Subject: San Jacinto River Waste Pits Superfund Site – Final Comments on Draft Feasibility Study

TECHNICAL REVIEW TEAM FINAL COMMENTS

Figure 3
 Relationships between Blue Crab Tissue and Surface
 Sediment Concentrations of 2,3,7,8-TCDD (ng/kg, ND=1/2DL)
 Bioaccumulation Technical Memo
 SIRWP Superfund/MIMC and IPC

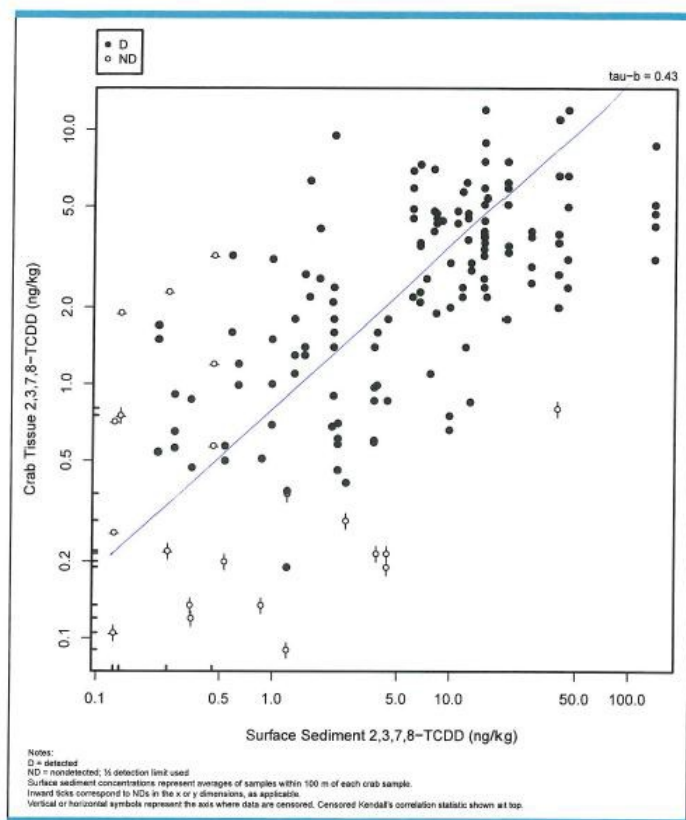
The BSAFs reported for blue crab in the RI are anomalously low relative to those reported by the UH/Parsons Team. In the figure below, the BSAFs reported for the three fish collection areas by congener are displayed with an “x” superimposed on box plots developed from data reported by UH/Parsons, which involved co-located sediment and crab samples from dozens of sampling stations throughout the Houston Ship Channel (HSC) and Galveston Bay system over several years. In many cases, the BSAFs reported are lower than any of the more than 100 values measured by UH/Parsons. This might be expected to result from a combination of high localized sediment PCDD/F concentrations in the Preliminary Site Perimeter (which constitute the denominator of the BSAF) with mobile organisms (crabs) that are exposed over their travels to less contaminated sites (and thus a lower BSAF numerator). However, the sediment PCDD/F concentrations utilized in the RI BSAF calculation are approximately equal to the average sediment concentration from the entire system reported by UH/Parsons, and the source of the low BSAF was instead found to be anomalously low levels reported in crabs from the site. The reported levels in crab are anomalously low even when compared to samples collected within the Preliminary Site Perimeter reported by UH/Parsons. We recommend that the source of this discrepancy be further investigated, as it represents one of the major PCDD/F exposure routes to humans. It may be due to differences in the

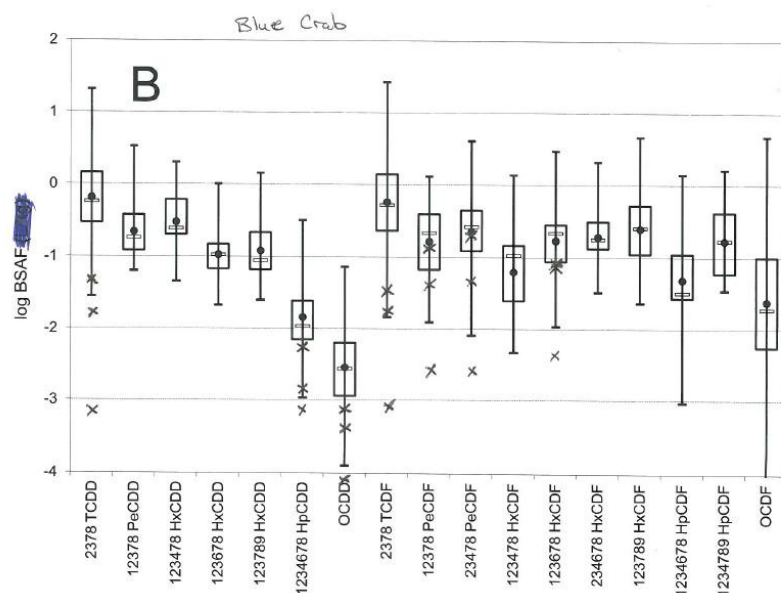
size/age of the crabs collected, or judgments on what portion of the edible meat was extracted from the carapace for analysis. This discrepancy was not observed for catfish tissue.

(a) TCEQ TMDL model of TCDD in the San Jacinto River, with observed concentrations

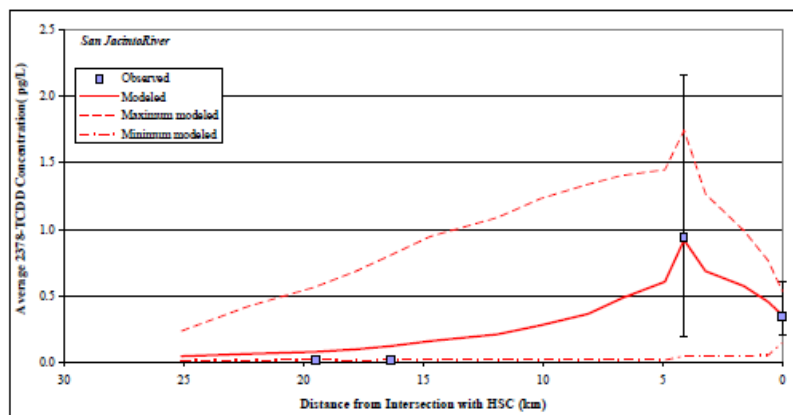
32) Section 3.2.2.1 of Appendix A, In Figure 3-14, the chemical fate and transport model for base case conditions shows water column concentrations of TCDD declining from approximately 0.06 pg/L at the upstream boundary below Lake Houston down to nearly 0.01 pg/L at river mile 5 upstream of the TCRA site, before rising to approximately 0.07 pg/L at the TCRA site, then rising further to approximately 0.2 pg/L at the lower boundary near the confluence with Buffalo Bayou. Neither these levels nor the pattern are supported by data collected by the TCEQ TMDL effort, even considering the model uncertainty bounds. The TCEQ TMDL data, measured between 2002 and 2012 using high- volume sampling for low detection levels, showed TCDD concentrations of no more than 0.1 pg/L upstream of the TCRA site, rising sharply to approximately 1 pg/L at the I-10 bridge near the TCRA (0.23 – 2.16 pg/L, average = 1.07 pg/L, n=6), then falling to an average 0.4 pg/L at the confluence with Buffalo Bayou. For comparison purposes, the model outputs of the TMDL model (a) and Feasibility Study model (b) are reproduced below. Because model predictions do not appear to overlap with observations, even after considering model uncertainty, we are concerned that the model does not accurately simulate sources of TCDD and processes controlling TCDD concentrations. It does appear to be a reliable management tool for evaluating remedial alternatives. Additionally, because the simulated concentrations underestimate water concentrations, we believe the remediation scenarios show a much greater impact on dioxin levels in the water column than could be expected. If the initial levels are high (as supported by the sampling data), then the remediation will not affect the overall concentrations significantly.
